Access Compliance Report Public Rights-of-Way (RR Crossings)

Intersection ID: 10025310	Main Street: E_5TH_ST	Location: N/A
ADA ID: 17946B909346	Overall Compliance: No	Severity Score: 0.0
Codes/Mitigation Info/Possible Solution		Field Measurements/Component Compliance

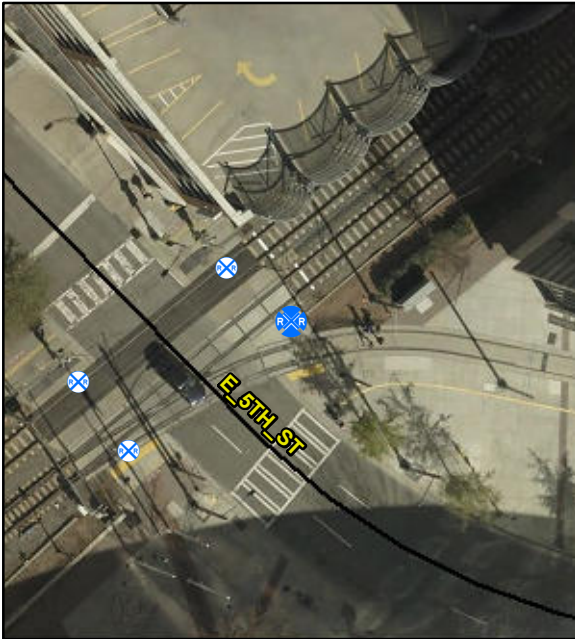
Compliance	Description	Data
Yes	DWS Provided?	Yes
Yes	DWS Contrast?	Yes
Yes	DWS Width (in)	Yes
Yes	DWS Length (in)	25.0
No	DWS Offset (in)	20.0
No	Pedestrian Gate?	No
N/A	DWS Outside Gate?	N/A
N/A	Rail Type?	LightRail
Yes	Flangeway Gap (in)	2.0
Yes	Sidewalk Width (in)	115.0

**Remove & Replace Detectable
Warning System. Provide Pedestrian
Gate.**
